AUSTRALIAN TECHNOLOGY PARK
- BUILDING 1
- BUILDING 2
- COMMUNITY BUILDING
- PUBLIC DOMAIN

ACCESS REVIEW

Morris Goding Accessibility Consulting

FINAL v2

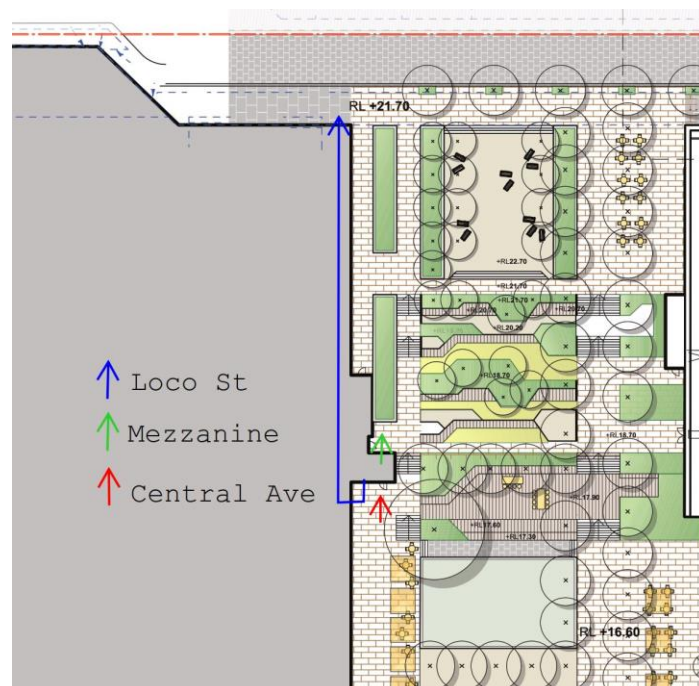
As per shown existing RL's, there are approximate gradients of between 1:75 – 1:100 across the accessible path of travel through the oval, complaint with AS1428.1:2009.

- (i) The provision of appropriate safety mechanisms to minimise the risk to people with a disability in relation to cyclists is preferred. Safety mechanisms include, but are not limited to, signage, chicanes, painted strips on pavement surface, and warning TGSIs.
